San Onofre Nuclear Generating Station
Unit 1

RESPONSES TO NRC REQUEST FOR
INFORMATION, TURBINE BUILDING RESPONSE SPECTRA

Impell Report No. 01-0310-1451
Revision 0

July, 1985

FIGURE 6

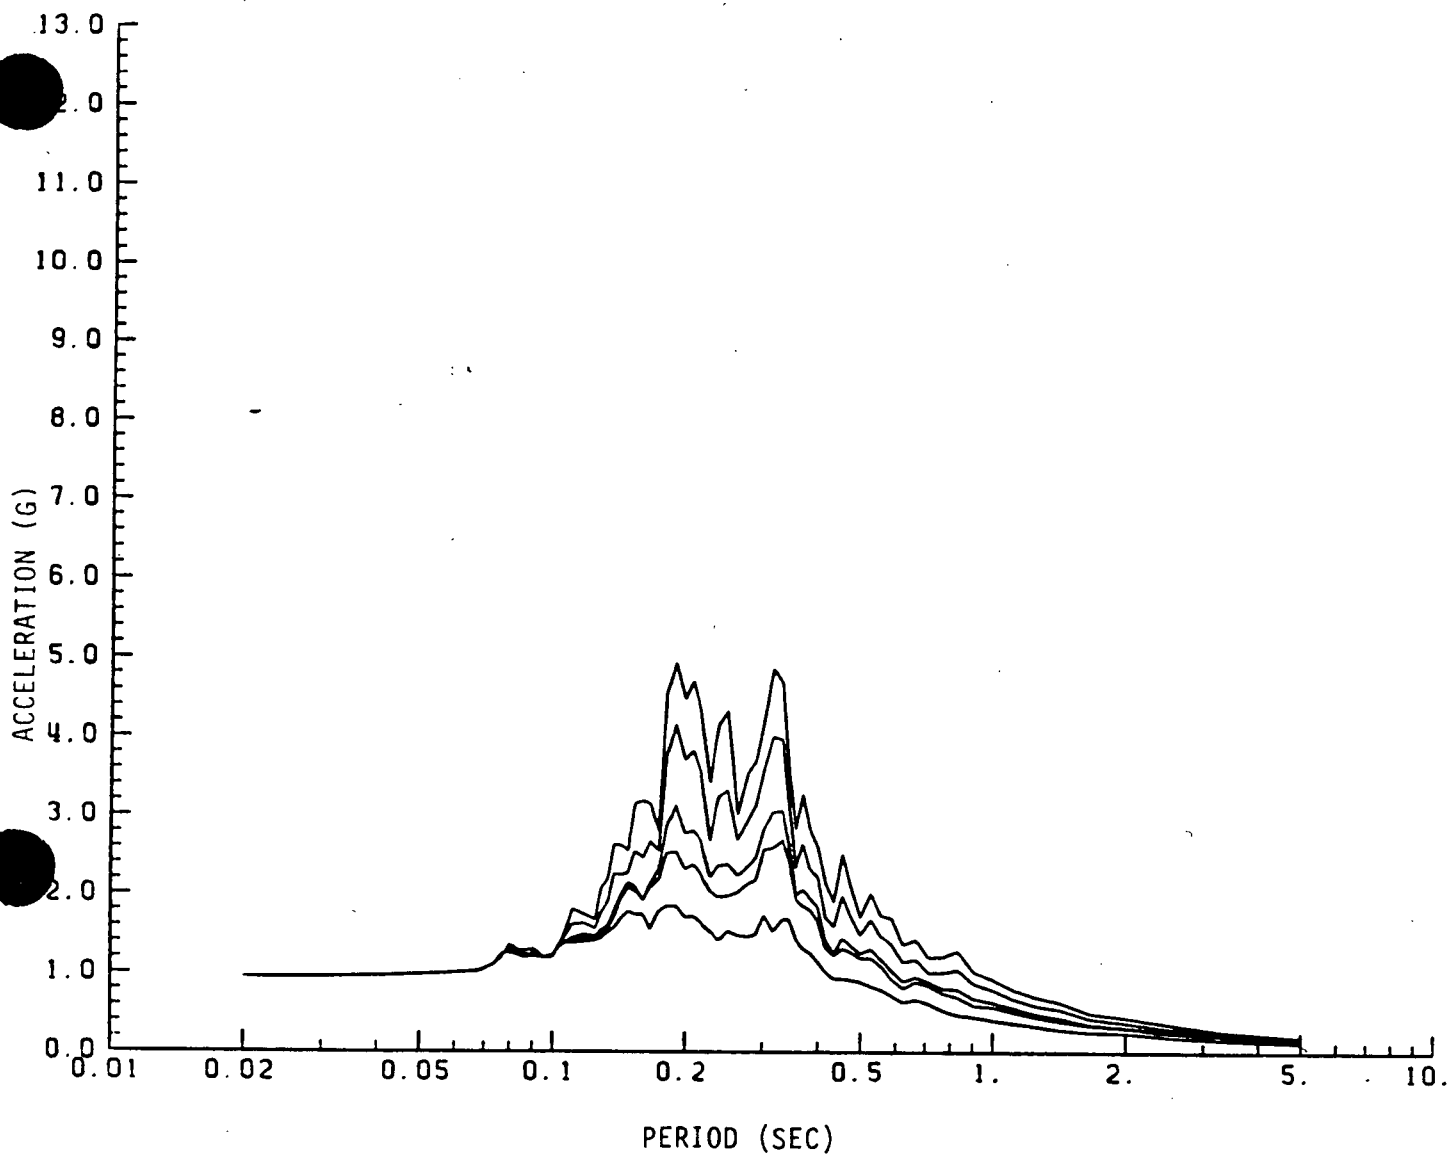
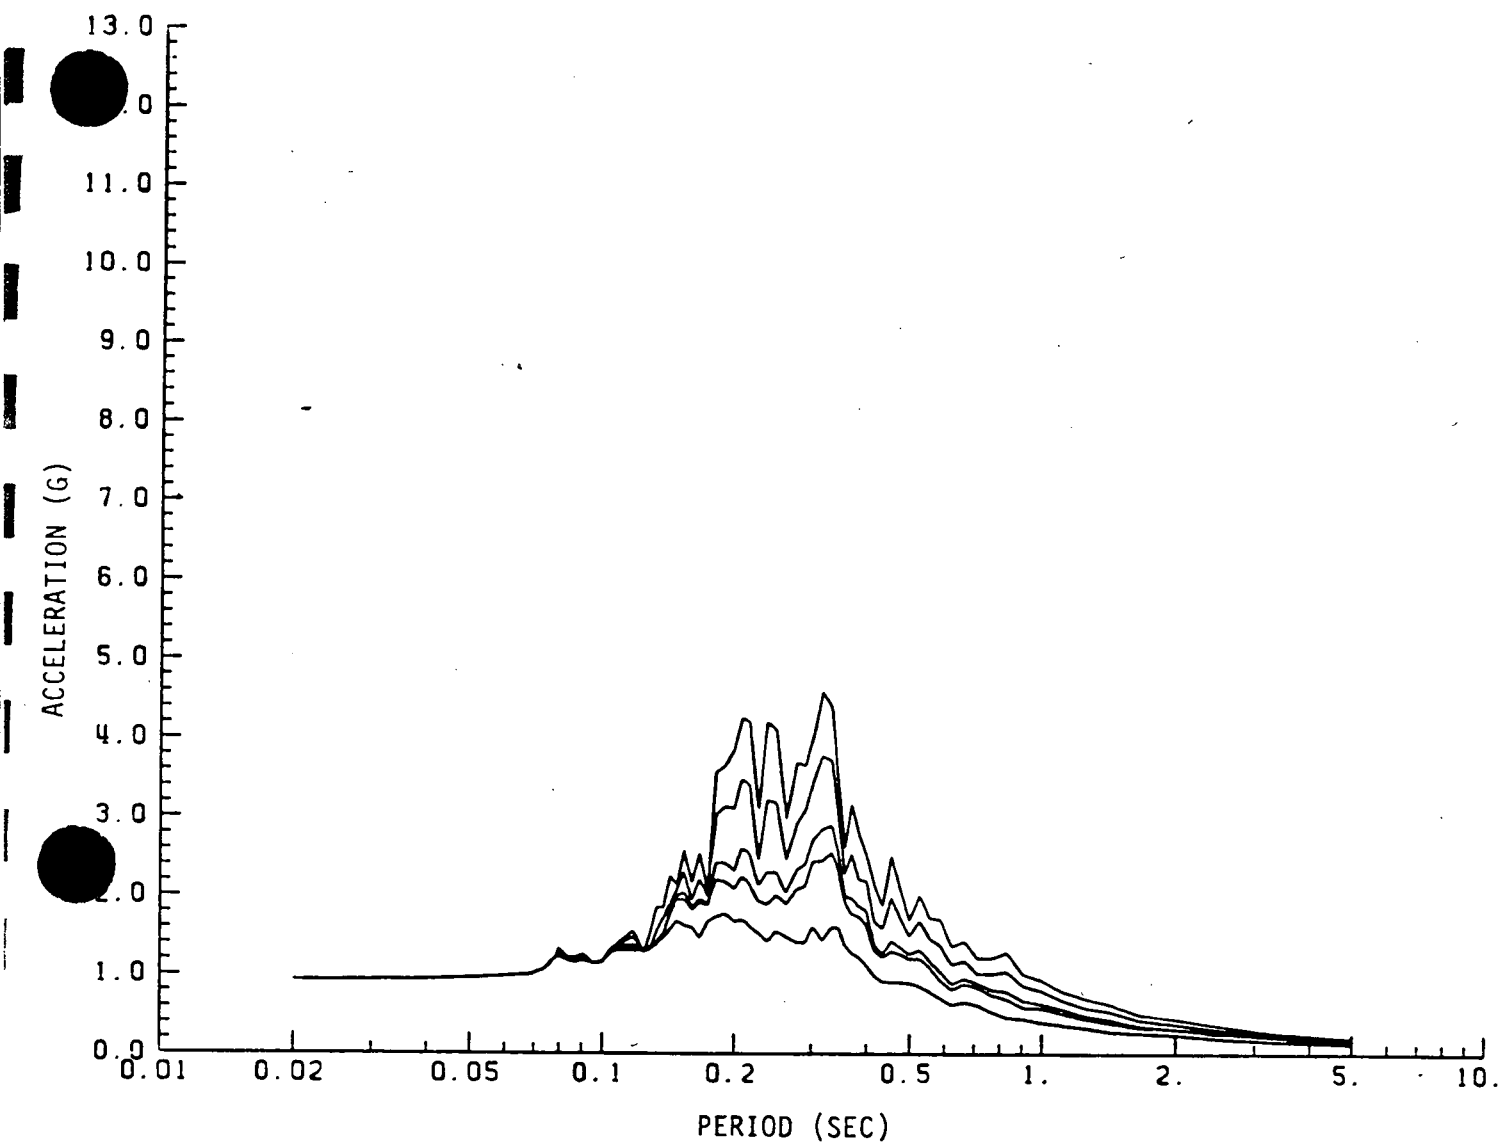
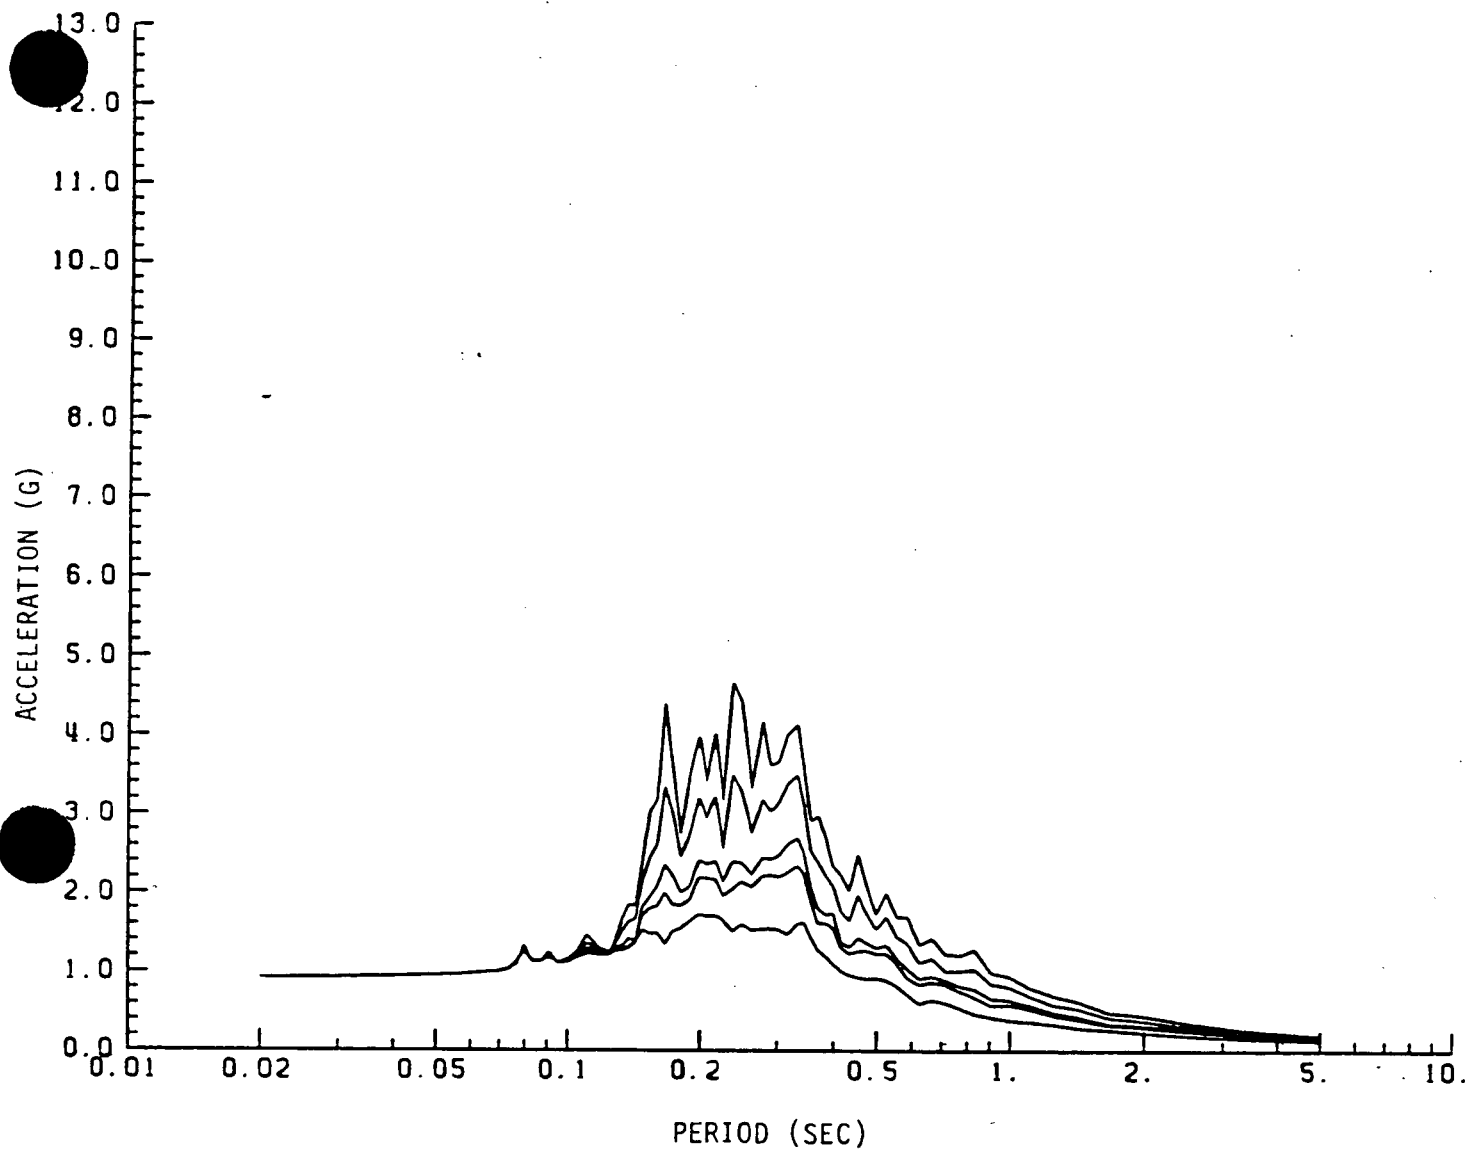
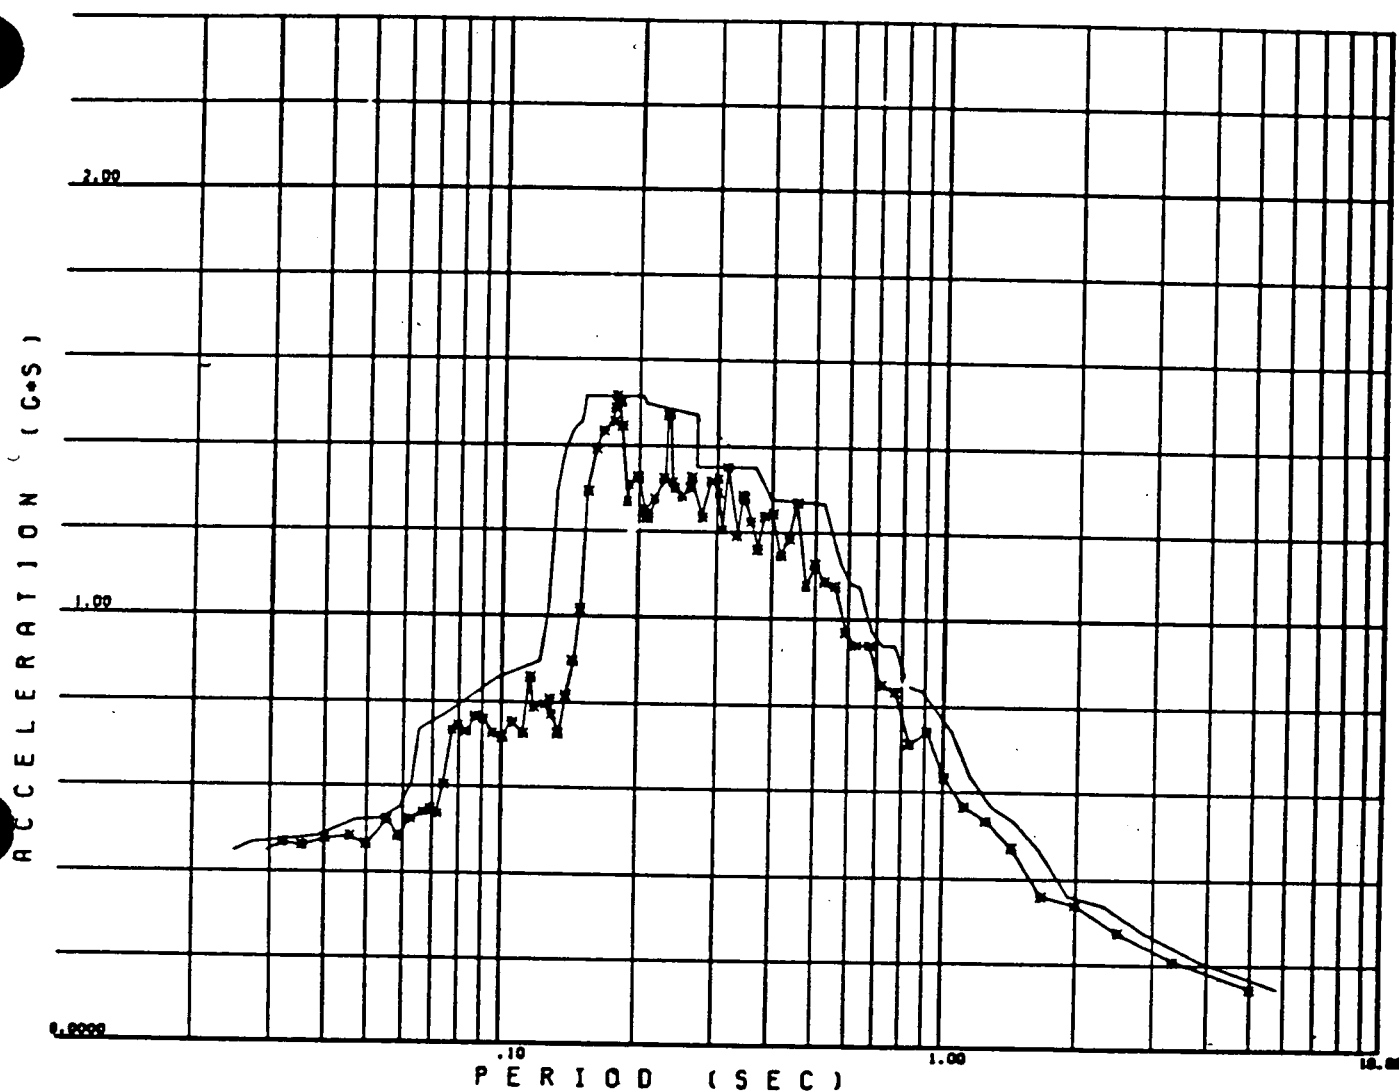
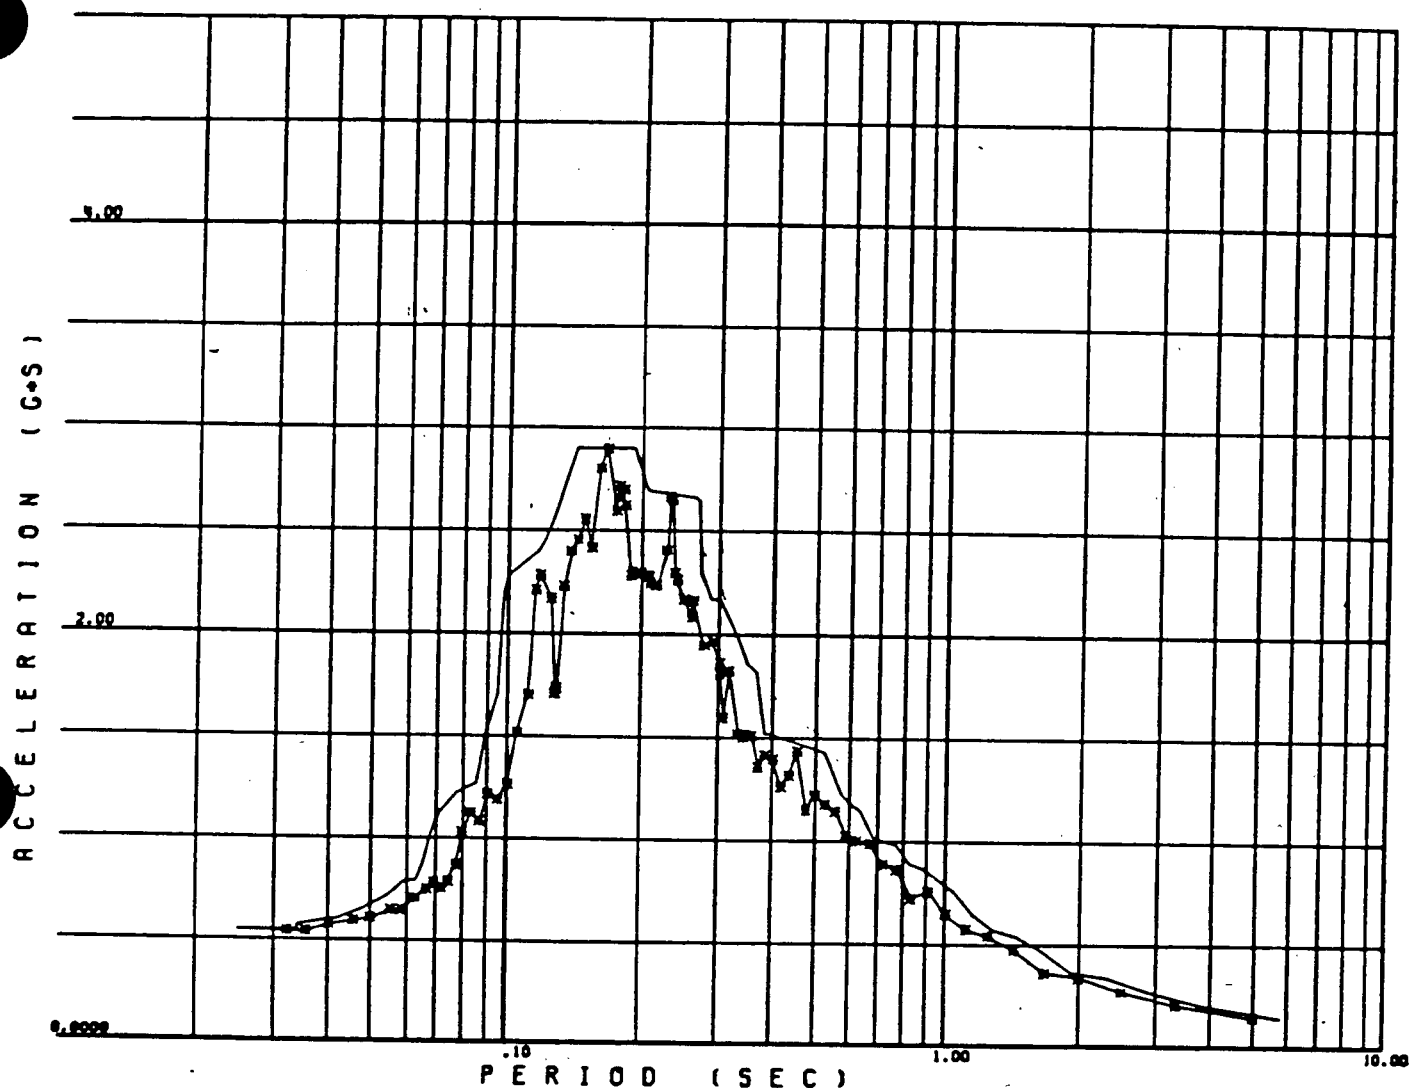
Provide comparison of Turbine Building floor response spectra with previous Bechtel spectra at two locations.

Raw response spectra, for 2% damping, generated by Impell and those generated by Bechtel are provided for the following locations:

- 1) Nodes 580, 586 and 610 in Area 2, North Extension, Elev. 42.0' for North-South Direction.
- 2) Nodes 29, 71 and 86 in Area 6, West Heater Platform, Elev. 35.0' for East-West and Vertical directions.
